## Product Change Notice (PCN)

PCN Number: **PCN-0450975R-01**

Product(s) Affected: SJ1-3523N, SJ1-3524N, SJ1-3525N

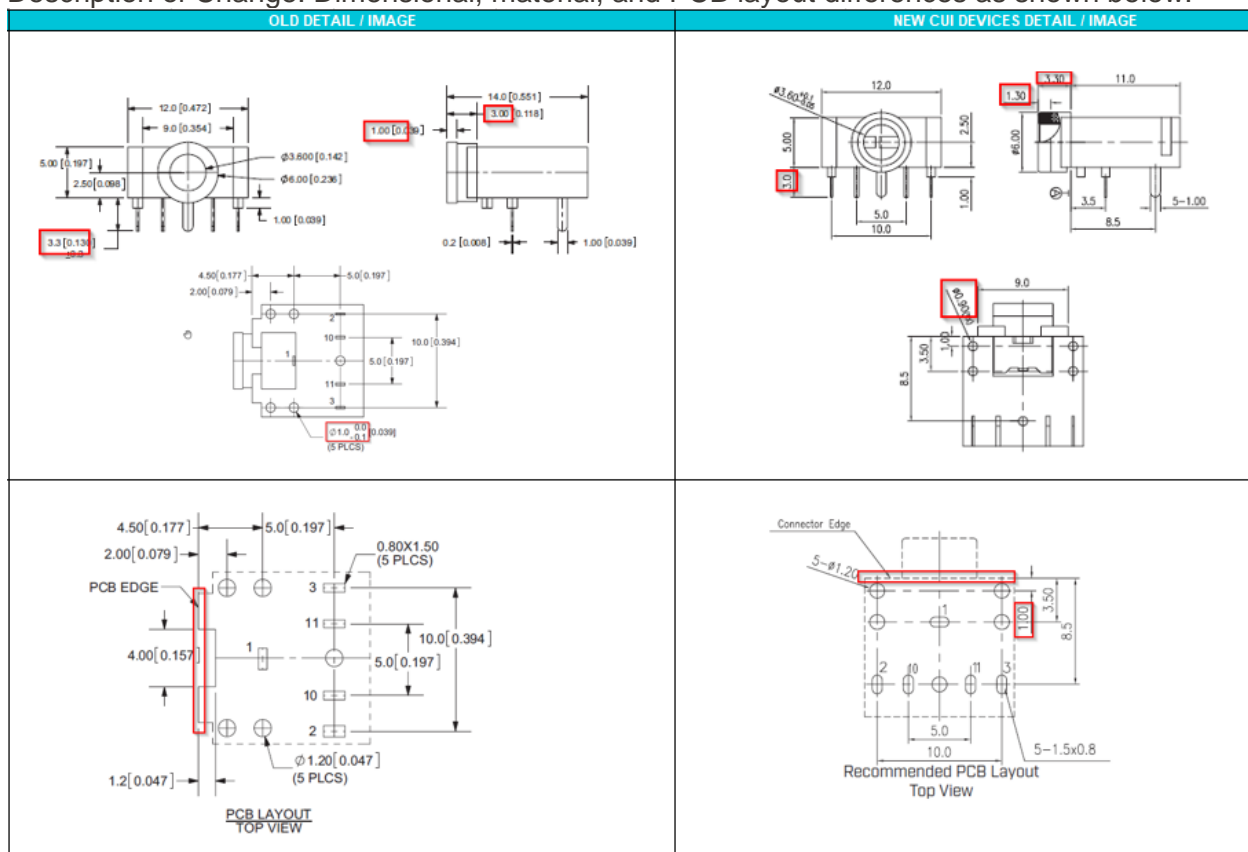
Description of Change: Dimensional, material, and PCB layout differences as shown below:

MATERIAL	PLATING
terminal 1	copper alloy	silver
terminal 2	copper alloy	silver
terminal 3	copper alloy	silver
terminal 10	brass	silver
terminal 11	brass	silver
bushing	brass	nickel
plastic	PBT

DESCRIPTION	MATERIAL	PLATING/COLOR
terminal 1	copper alloy t=0.20	silver over nickel
terminal 2	stainless steel t=0.20	silver over nickel
terminal 3	stainless steel t=0.20	silver over nickel
terminal 10	brass t=0.40	silver over nickel
terminal 11	brass t=0.40	silver over nickel
bushing	brass	nickel
housing	PBT (UL94V-0)	black
